# Work Order ID 85312

Item Name: Float Skidtube Installation

Reference: RMA RA111368

## **Instructions for RA111368 D412-742-013 B83616 CHG007**

**D3391-041 FLOAT SKIDTUBE ASSEMBLY PARTS LIST**

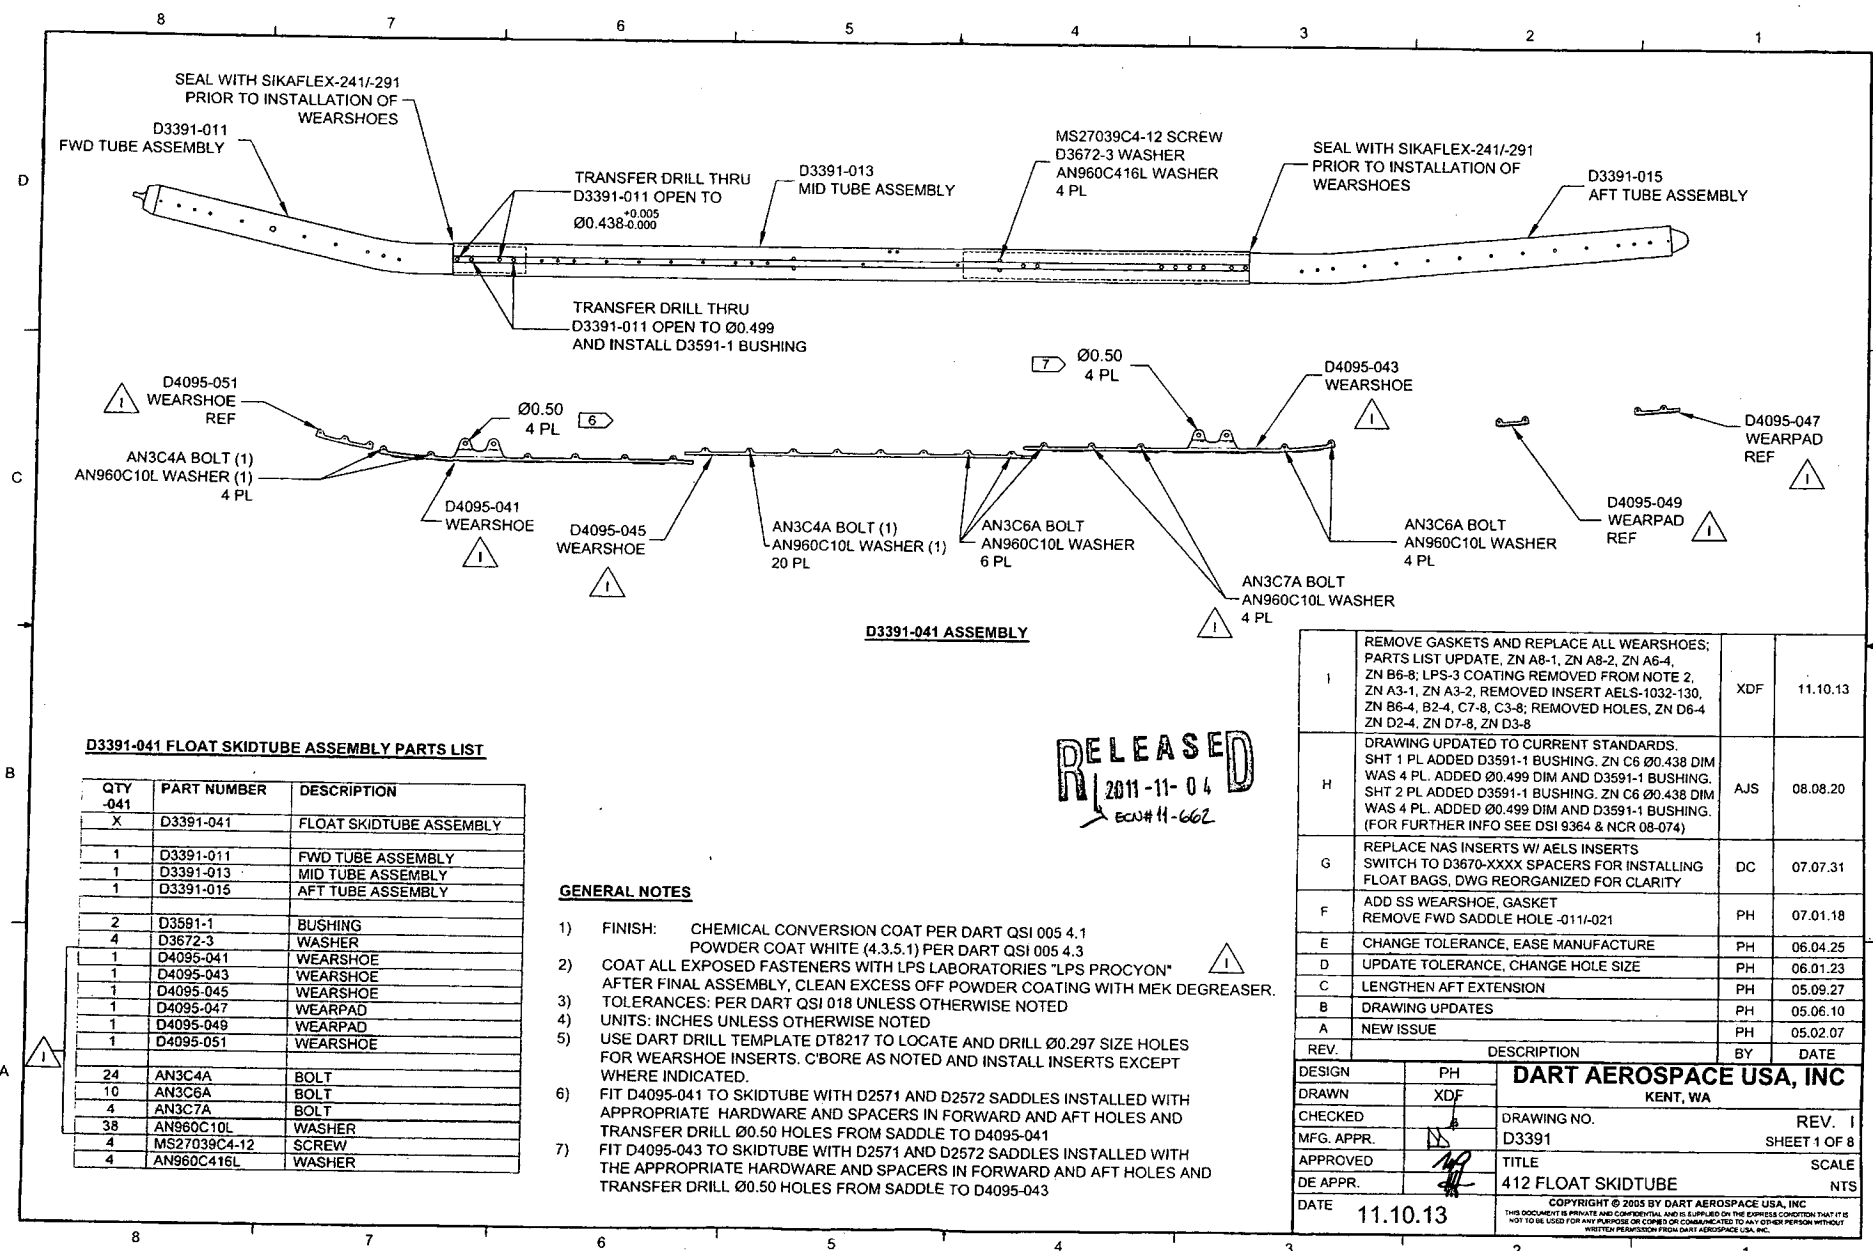
INSPECT RA 111368 D412-742-013 B 83616

BUFF OUT MARKS FROM SHIPPING DAMAGE

ENG APPROVAL NEEDED BEFORE CONTUNING

TOUCH UPS NEEDED ON FWD CAP

BUFF MARKS ON D3391-023 AND WAIT ON ENGINEERING APPROVAL  
ON WHETHER PART IS SAVABLE

W/O:		WORK ORDER CHANGES					
DATE	STEP	PROCEDURE CHANGE	By	Date	Qty	Approval Chief Eng / Prod Mgr	Approval QC Inspector
12/06/25	110	Assemble with: NAS1330C3K13-116/M10337 inserts AHS4:1032-225/M121269 (inserts)	ju	12/06/25	X4 X10

TOUCH UP AND RE-ASSEMBLE PER DRAWING

INSTALL NEW HARWARE AND DISCARD OLD HARDWARE

\*ENG TO DETERMINE WHETHER TO REPLACE MID TUBE\*

**D3391-1 CUTTING DETAIL**  
(MAKE FROM D6013-047 SKIDTUBE MATERIAL)

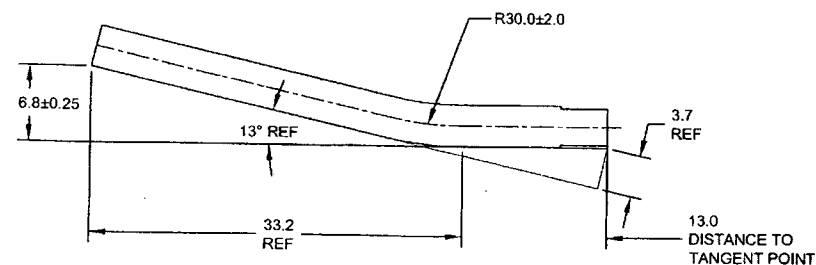
The tube was gouged, on the top of the ridge, and just above the ridge. It's located 38.8" from the fwd edge of the mid-tube, ie. approximately in the middle of the tube. They've buffed out the affected region, leaving an approx. 0.5" x 0.5" area with a wall thickness of 0.087". The D2500 gives the wall thickness at 0.100+/-0.010. The surrounding area is 0.099" wall.

If this was a production tube and the damage was from excessive grinding, I would be inclined to accept the tube because the wall thickness is close to being in tolerance, located near the neutral axis, and located on the top of the tube where it's not likely to be hitting rocks and such. But because the damage is from a hard impact with an object, I am inclined to get your approval.

We can also build the area back up with welding. It's in a region where the ICA allows weld repairs.

Agree that is acceptable to repair this damage and salvage the tube.
